Service Information

Category B	Repair Guidance	Ref. No. R003/13 B	Page 1 of 5
Coverage <input type="checkbox"/> Distributor only <input checked="" type="checkbox"/> Please inform your dealers		Date Issued January 17, 2013	
Please convey this information to your <input type="checkbox"/> Director <input checked="" type="checkbox"/> General Manager <input checked="" type="checkbox"/> Warranty Dept. <input checked="" type="checkbox"/> Parts Dept. <input checked="" type="checkbox"/> Training Dept. <input checked="" type="checkbox"/> Field Rep.		Date Revised April 10, 2013	
Applicable Model Mazda6(GJ) with SKYACTIV-D 2.2	Applicable Countries or Specifications Australia, New Zealand and Europe.

REVISED

Subject: Clinking/Hissing noise from the front right side of vehicle

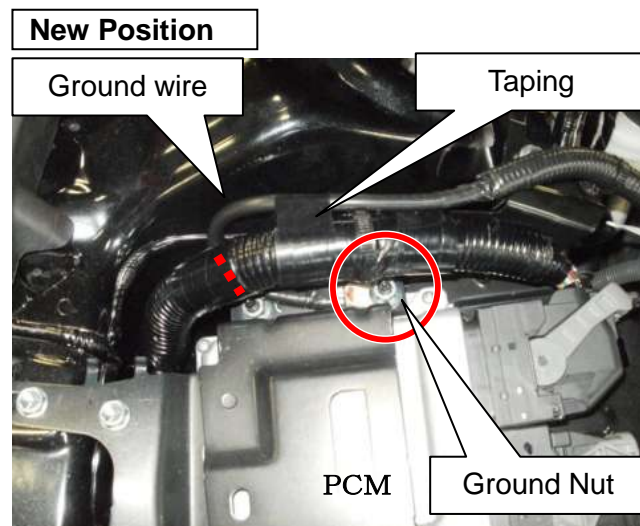
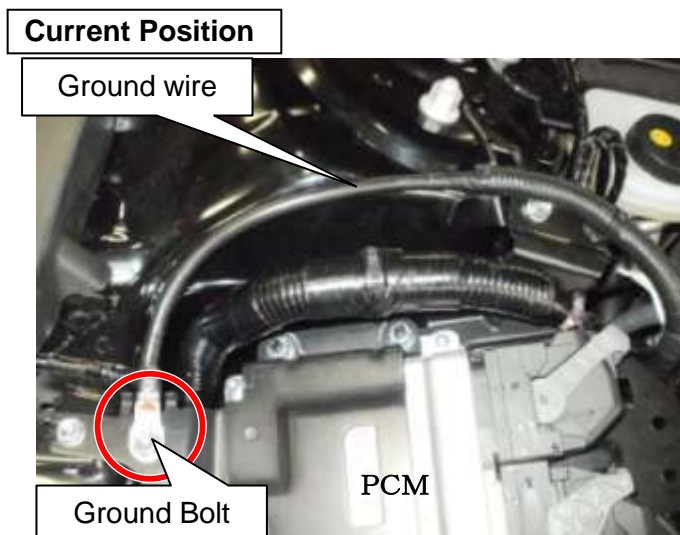
The engine noise is transferred and amplified by the ground wire. Then the noise can be heard from the front right side of vehicle.

Change the installation location of ground harness using a heat-resisting tape (PVC Tape).

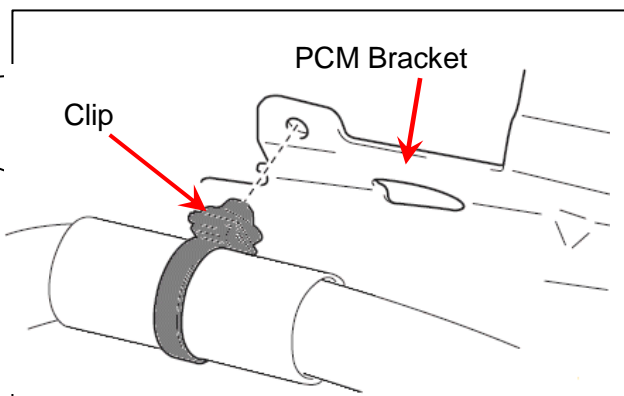
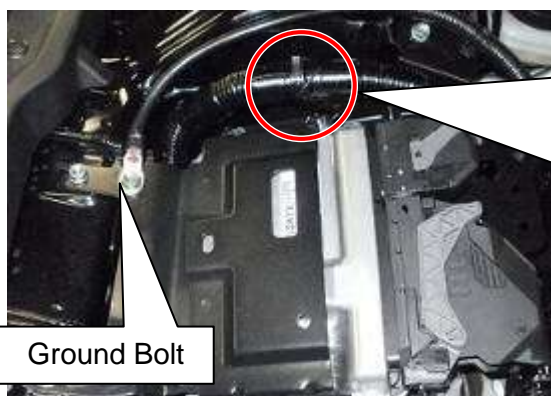
1. Detach the clip from the PCM bracket.
Note: To detach the clip, pinch it by pliers.
2. Remove the ground bolt.

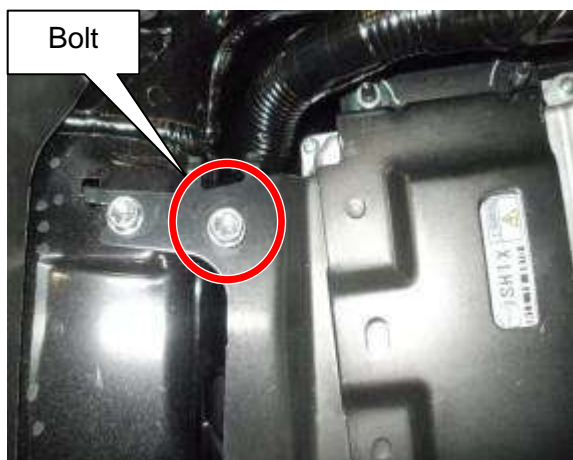
3. Install the removed bolt to the original position.

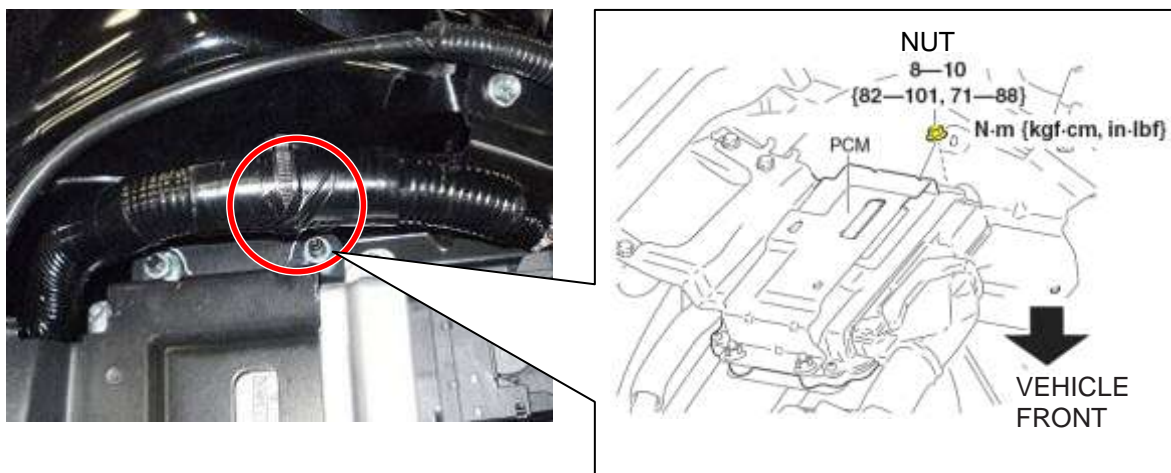
4. Remove the nut from the PCM bracket.

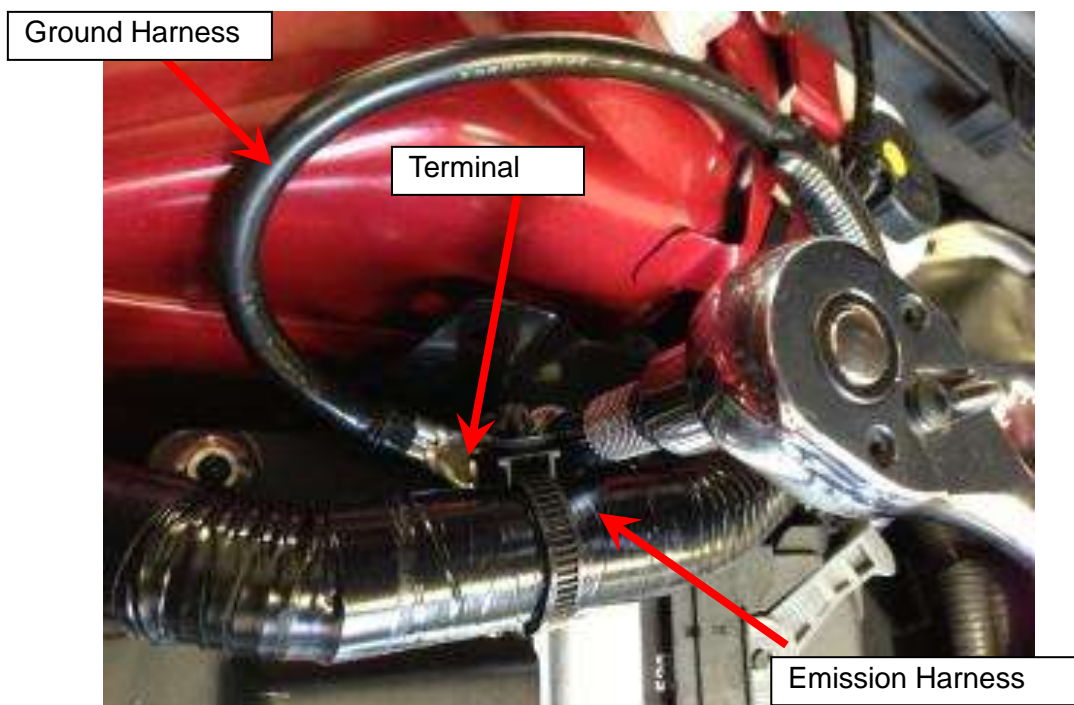
5. Route the ground harness between the emission harness and the body, then install the terminal of the harness to the PCM bracket using the original nut as shown in photo below.

6. Tighten the nut.

Tightening Torque: 8-10 Nm{ 82-101 kgfcm, 71-88 in-lbf}

Note: While tightening the nut, hold the terminal by hand to prevent it from turning.

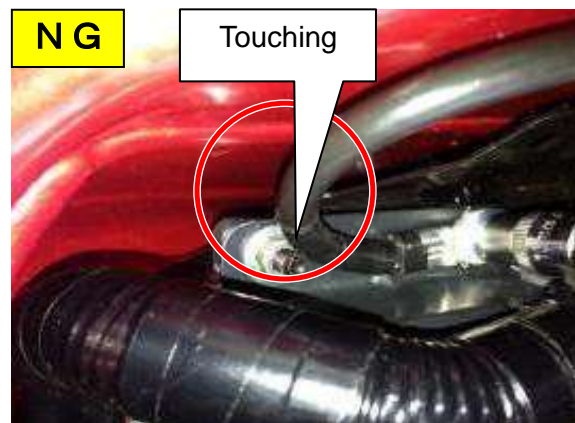
Caution: To prevent the ground harness from touching the nut & stud bolt, route the ground harness as shown below.

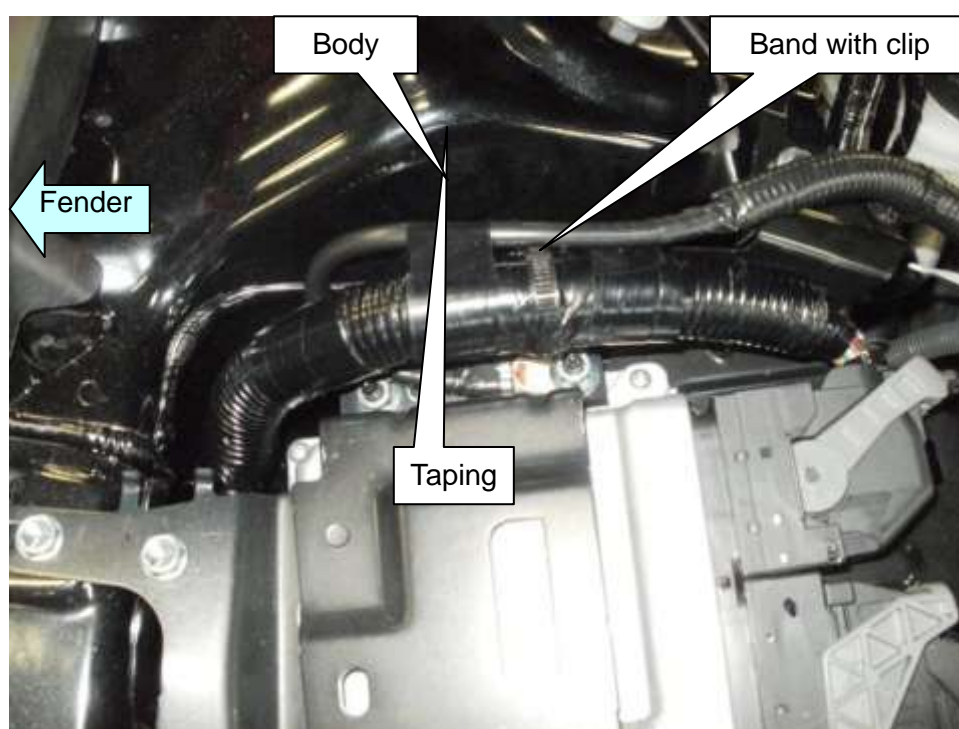
8. Affix the ground harness to the emission harness with a heat-resisting tape (PVC Tape) as shown in photo below.

Caution: To prevent the ground harness from touching the body, route the ground harness as shown below.
